U. S. Department of Labor

Subject: Mine Ventilation Plan, Section 75.370, 30 CFR 75, Upper
Big Branch Mine - South, I.D. No. 46-08436, Performance
Coal Company, Montcoal, Raleigh County, West Virginia

RE: Performance Coal Company - Upper Big Branch Mine-South
Federal I.D. 46-08436, State I. D. U-3042-92 – Ventilation Plan

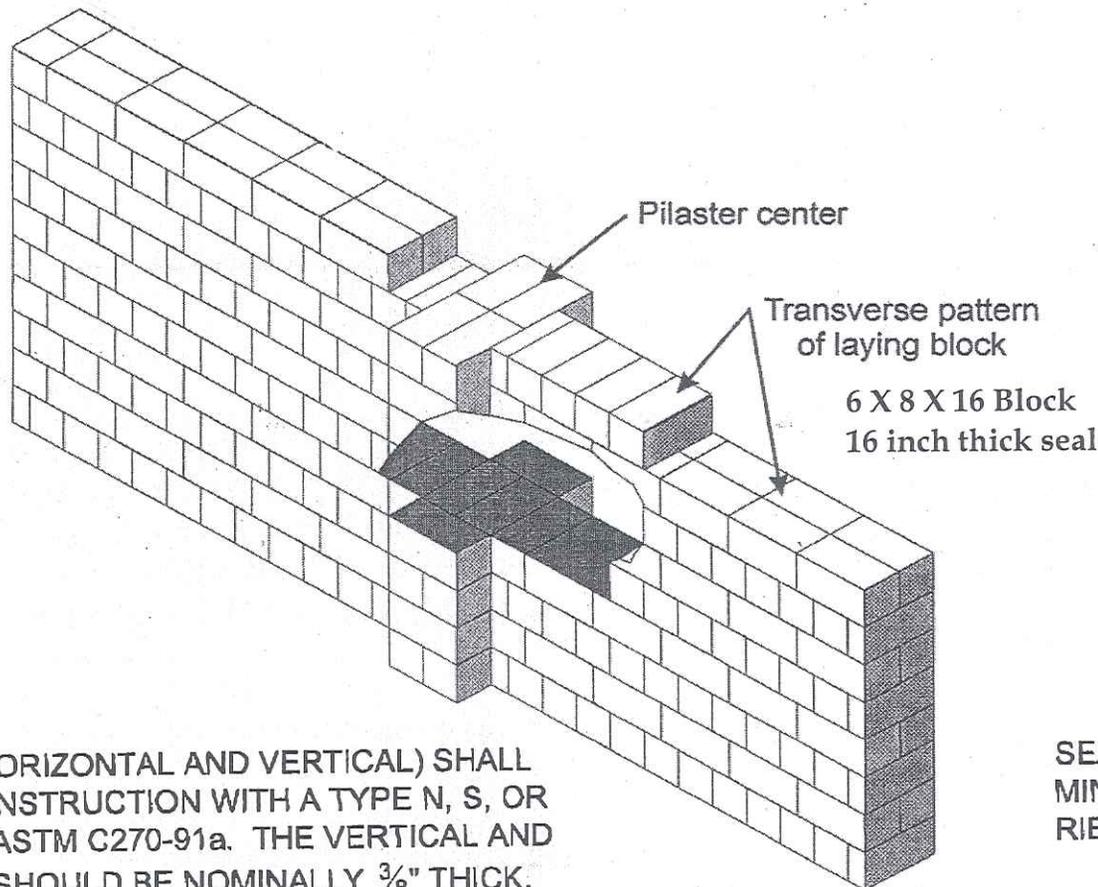
Performance Coal Company, Upper Big Branch Mine-South (ID 46-08436), is requesting approval to permanently seal the remaining longwall gob and bleeder. This is to be done in lieu of driving additional entries to access four EP's behind the longwall. Attached are two maps of a portion of the mine showing the locations of the proposed thirty two (32) underground seals. The first map shows the ventilation as is but with the 23 "A" seals already built. These seals will not affect ventilation. The second map shows the proposed changes to be made after completion of the "B" seals and while the remaining seal is being built. This change will change the ventilation in North Mains and along the entire main entries to make North Mains sweep ventilation with air going from right to left. The return will be directed past the newly built seals and directed to the outside.

The underground seals will be constructed in accordance with 75.335a1.

Seals are numbered sequentially from south to north and then to the west. Seals with a designation of (A), can be built at any time and in any order. Seals with a designation of (B), can be built at the same time as the adjacent seals with an opening left in the seal equivalent to the size of the EP opening at that location such that the EP can continue to take at least the same amount of air that was flowing through it prior to that seal being started. The seal with the designation of (C), will be partially built when the (a) seals are built. After completion of the (B) seals, seal (C) will be completed as the North Mains air change is started. When this ventilation change takes place, no one will underground except those assisting with the change in accordance with 75.324.

SEAL TO BE HITCHED A MINIMUM OF 4" IN THE FLOOR AND RIBS.

EACH SET OF SEALS WILL BE PROVIDED WITH ADEQUATE SIZE WATER TRAP(S) AND AIR SAMPLING TUBE

SEAL SHALL BE COATED ON ALL ACCESSIBLE SURFACES WITH A FLAME RETARDANT MATERIAL THAT HAS A FLAME SPREAD INDEX OF 25 OR LESS

INTERLOCKED PILASTER OF MINIMUM 16" X 32" SIZE

SEAL MAY BE BUILT 24" OR MORE IN THICKNESS WITHOUT A PILASTER

ALL BLOCK JOINTS (HORIZONTAL AND VERTICAL) SHALL BE FULL WET-BED CONSTRUCTION WITH A TYPE N, S, OR M MORTAR MEETING ASTM C270-91a. THE VERTICAL AND HORIZONTAL JOINTS SHOULD BE NOMINALLY $\frac{3}{8}$ " THICK, NOT TO EXCEED $\frac{5}{8}$ " OR LESS THAN $\frac{1}{4}$ " IN THICKNESS

SEAL TO BE SET BACK A MINIMUM OF 10' FROM THE RIB (BLOCK) CORNER
